**Product Change Notification:** PCN-21-107912

D3200 REC housing

NUMBER 917659

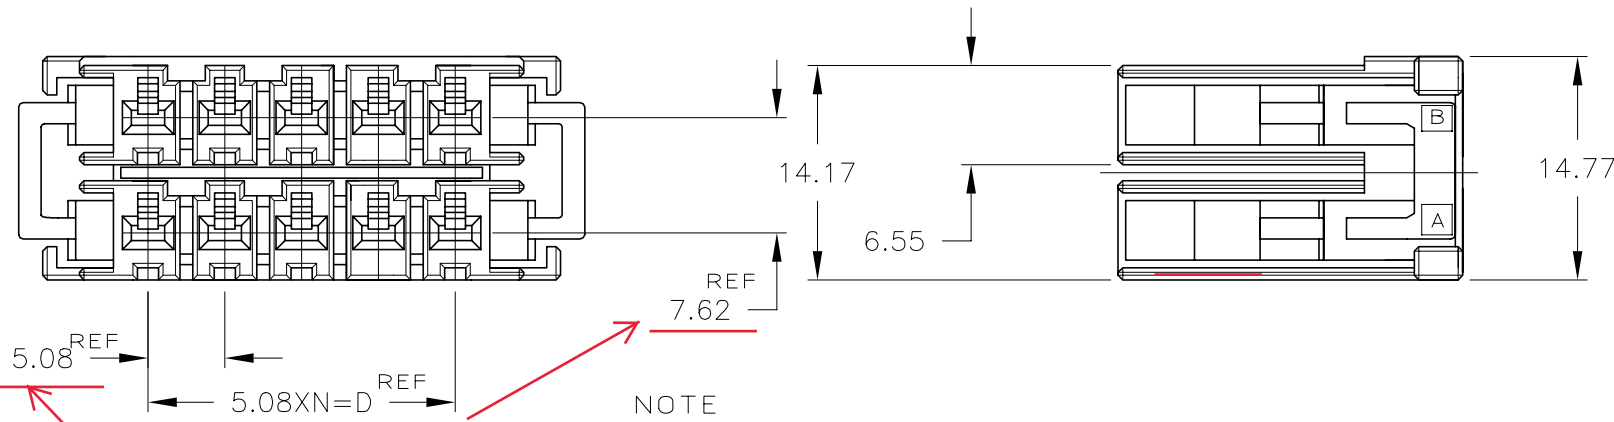
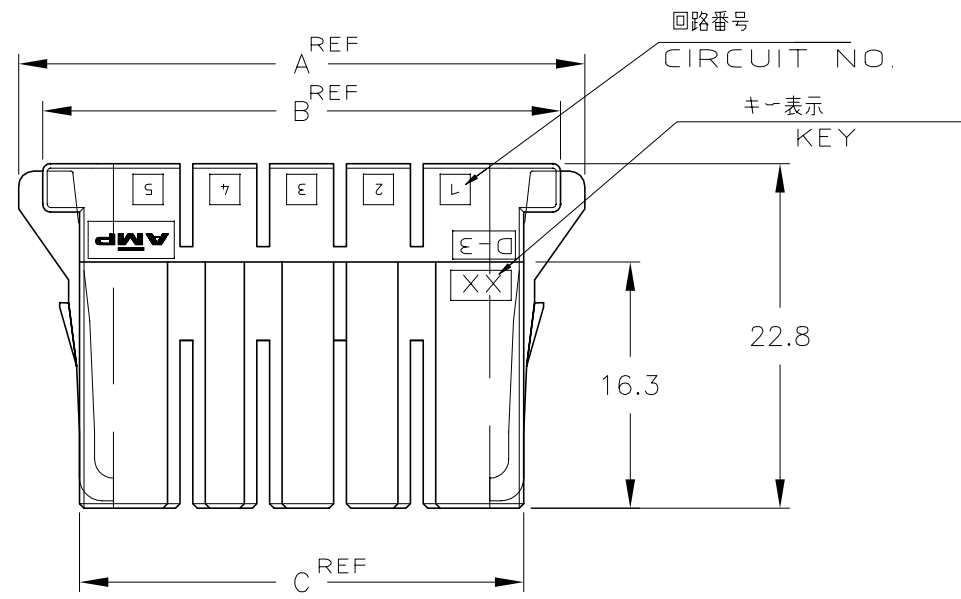
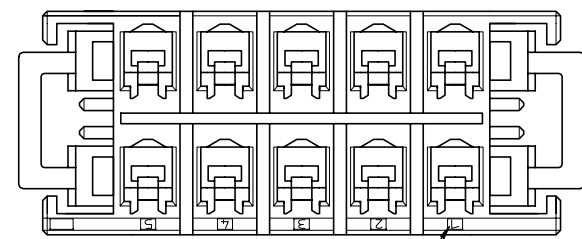
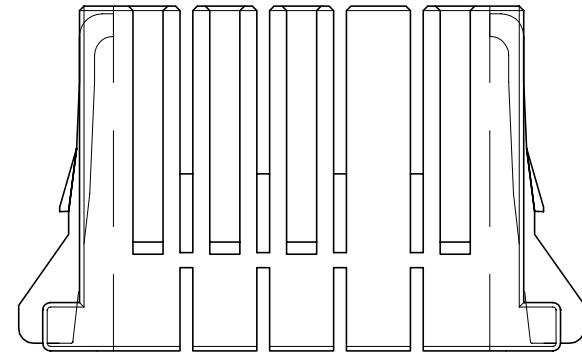
Pitch information is for reference only, so it is corrected to the reference dimension.

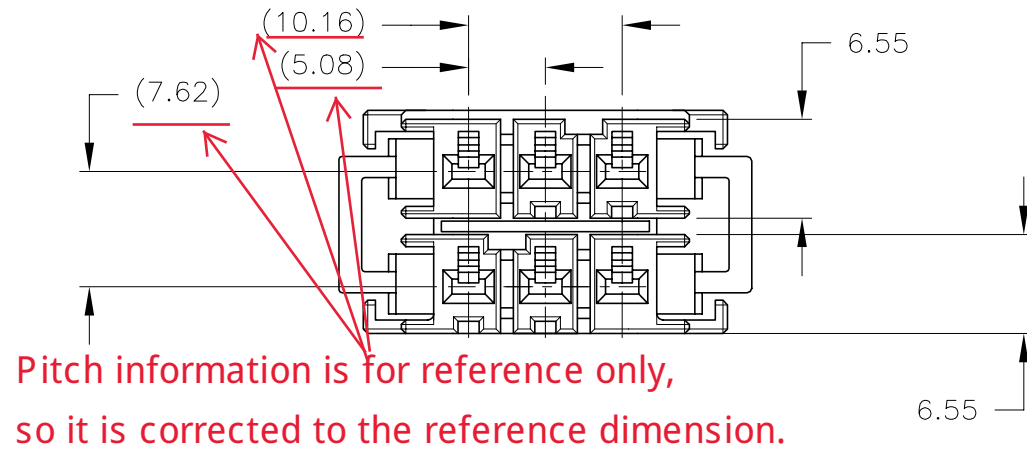
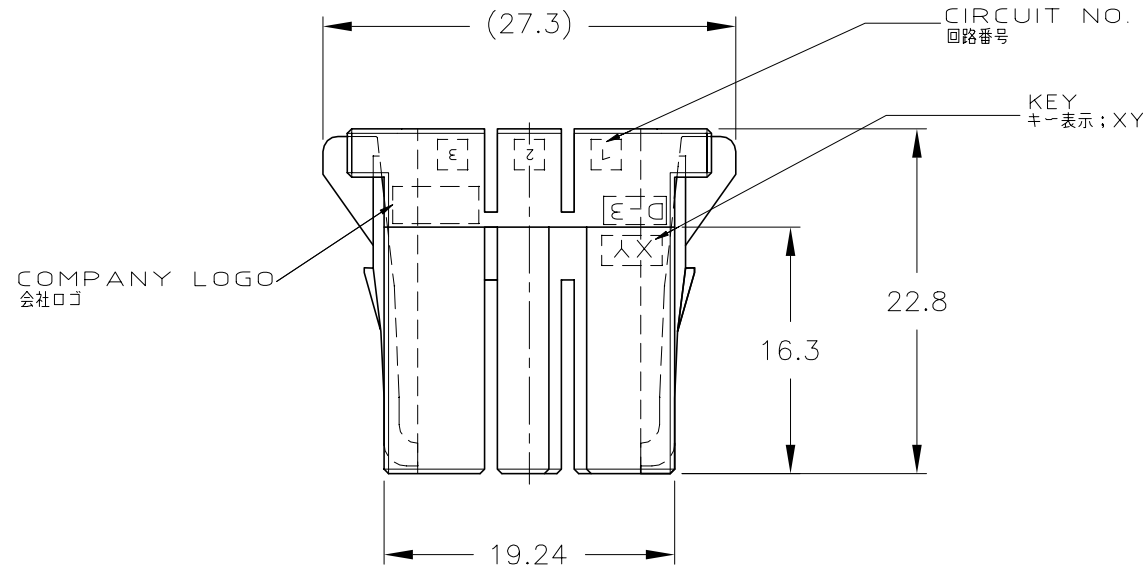
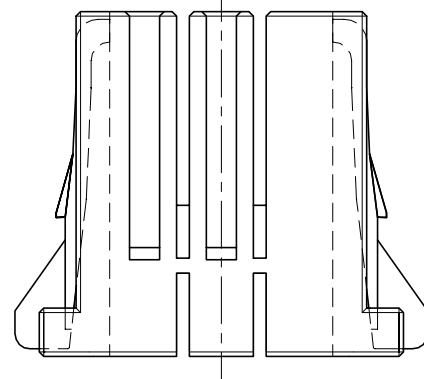
P	LTR	DESCRIPTION	DATE	DWN	APVD
	H	REVISED	21JUL2021	Y.O	T.S
